Correspondence.

The discussion upon the Paper “On the Construction of a Concrete Railway-Viaduct,” by Messrs. Wood-Hill and Pain, occupied the evening.

Figs. 12.

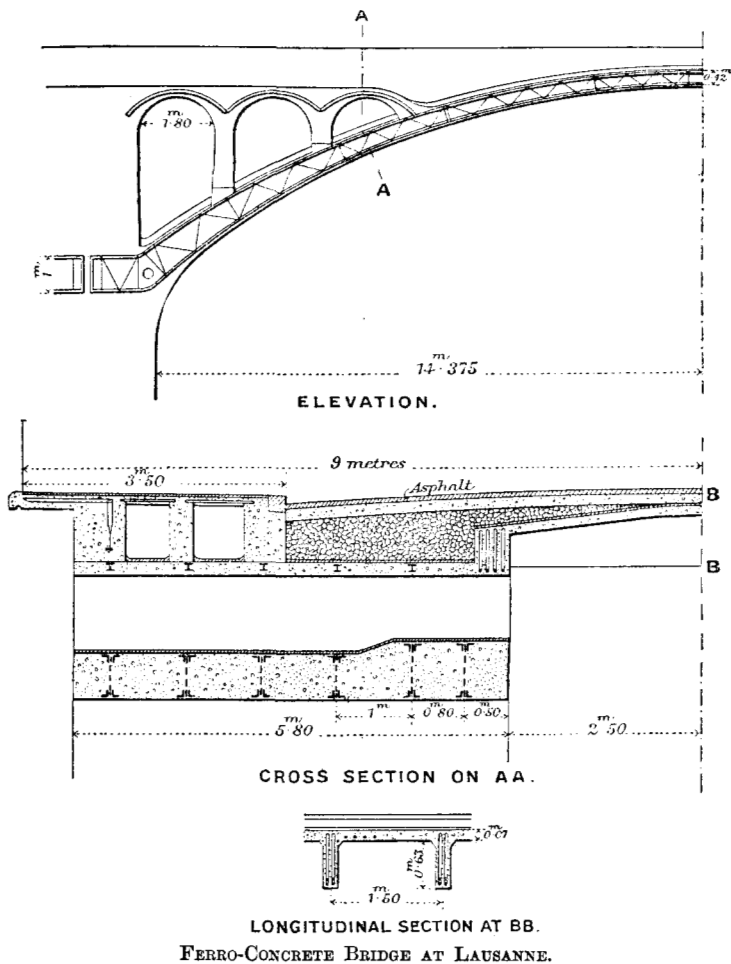
Prof. Gaudard. some years, the filling up of the valley of the River Flon would ultimately bury the lower portion of this work, in the same way as the lower arches of the Pichard Bridge, in the same town, had disappeared. The stone piers had been consolidated

by a course of masonry in reinforced concrete, which was prolonged through the opening between the two pillars forming one pier. The two higher piers had a second similar course but without this prolongation. The Montbenon abutment had had to

be subsequently strengthened with rectangular beams of reinforced concrete, in consequence of signs of movement of the earth. From a similar cause, namely, the existence of slipping strata, determined by Professor M. Lugeon, it had been necessary to pull down several foundations, to the extent of 6 metres (19.68 feet) in the base of one of the piers. In the bridge at Lausanne the elliptical form of arch had had to be adopted by reason of the filling up of the valley of the Flon, which would otherwise have risen above the springing; and moreover the metallic reinforcements of that work were better suited to the elliptical form. In France there existed a preference for the full-centered arch wherever it was possible to adopt it, because of the better conditions in that form as regarded the thrust upon the piers in the event of any one of the adjoining arches becoming overloaded; as for example the 25-metre (82-foot) openings of the Crueize viaduct on the Marvejols-Neussargues line, and even the four 50-metre (164-foot) spans of the viaduct of Nogent-sur-Marne. The spandrels were at the same time lightened by internal vaulted spaces.

Fig. 13.

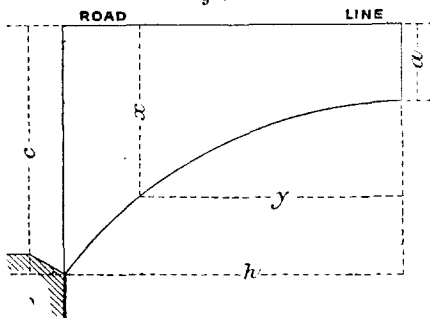
the ratio of rise to span was rather high, namely, 1 : 3; with Mr. Metcalfe. equilibrated arches a ratio of 1 : 10 was quite practicable. He had himself made the calculations for, and been engaged upon the design of, viaducts and bridges in which the ratio of rise to span was respectively 1 : 4 and 1 : 8; these bridges had proved in every way satisfactory and looked extremely well in elevation. Of course, such a ratio as 1 : 10 or 1 : 8, demanded good ground and massive, suitably-designed abutments. In the case under discussion this would have been an advantage, because the abutment-piers could have been moved forward and at the same time lengthened, thus doing away with spans Nos. 1 and 10 and the piers adjacent to them; which would have obviated the risk of exposing the piers to thrust from a possible slip of the earth in the banks. In order to avoid moving forward the abutments, the spans might have been lengthened slightly. He thought there were two principal reasons why elliptical and semicircular arches were more frequently met with than those of the correct form. One was that designers had overlooked the fact that there was an intimate relationship between the curve of thrusts, the curve of a suspension-bridge, and the curve of bending-moments for the same span and the same distribution of load. The other was that no convenient means for calculating and plotting the curve of equilibrium in the case of masonry and concrete arches was readily accessible, or even generally known to exist. At the beginning of the nineteenth century Dr. Charles Hutton investigated the conditions of stability of the arch and deduced a formula expressing them. He considered two cases, namely:—(1) Given the outline of the intrados of an arch, to find the form of the extrados or profile of the roadway which would keep the arch in equilibrium, the thickness at the crown and the span being given. This case was of little practical interest, though it was of theoretical value. (2) Given the outline of the extrados or upper surface of the roadway, to find the form of the intrados of the arch under which it would be in equilibrium, given the thickness at the crown of the arch and the span. This was the case which most frequently occurred in engineering practice where railways, roads, or canals were carried by an arch; and it was of great interest. For the case of a horizontal extrados (*Fig. 13*), the equation to the equilibrated curve of thrusts assumed the special form—

Mr. Metcalfe. where the thickness at the crown = a , the half span = h , and the rise + the thickness at the crown = c ; the origin of co-ordinates being the intersection of a vertical line through the middle of the key-stone with the extrados, which in this case was a horizontal line.¹ Calculation was simplified by taking the logarithms of both sides

The application of the equation was illustrated by the case of a road-bridge, proposed and designed on this principle by the late Mr. Charles Richardson, M. Inst. C.E., for crossing a railway-cutting

Fig. 14.

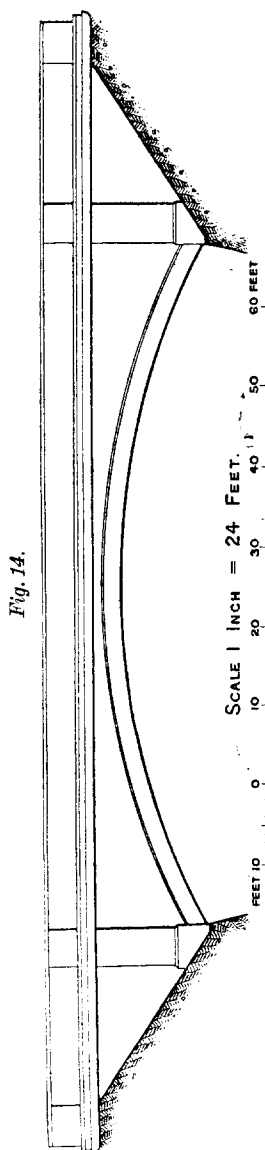
The elevation of the bridge was shown in *Fig. 14*. This bridge Mr. Metcalf. would require the arch to be 13 inches thick at the crown, and 15 inches at the springing; and for convenience in building it of brickwork, it would be made 15 inches thick throughout. A 50-ton engine of the common gauge, with a 16-foot wheel-base, would produce a lowering of the crown, when at the centre of the span, of nearly 3 inches, but, as there was a margin of 12 inches thickness to spare, the bridge would be safe under a travelling load of even 100 tons. There was no reason, except the cost of centering, why arches of 400 feet span should not be built of vitrified bricks. With regard to materials, he thought brickwork in cement was a better material than concrete; certainly it was more reliable, and in most cases it would cost less than the amount mentioned by the Authors, though, for the particular case they were dealing with, concrete was doubtless the cheapest material. If arches were built in brickwork, they should be built in vertical bond as shown in *Fig. 15*, and not in rings, which did not unite to form a solid block arch, but had a tendency to separate, the line of thrust passing from one ring into another. Bricks of the highest quality were preferable even to large stone voussoirs, as, being small and handy, they could be swum in the cement mortar and made to take a full-bedded bearing. This it was not easy to do with large voussoirs, which were also liable to be hollow-dressed and to cause the joints to break at the edges owing to the squeezing out of the mortar under pressure. When vertical bond was used for tunnel-work where the radius of the arch was small, the bricks indicated in *Figs. 15* by S_1 and S_2 should be specially-made tapered bricks. They added 4s. or 5s. per 1,000 to the

Fig. 15.

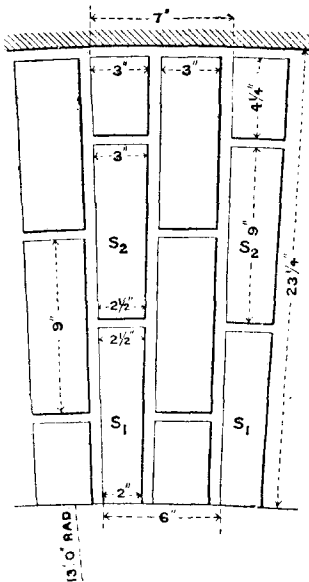
Mr. Metcalfe. cost, but made a better job; and bricklayers soon got to know them and use them without confusion. Vertical bond was of
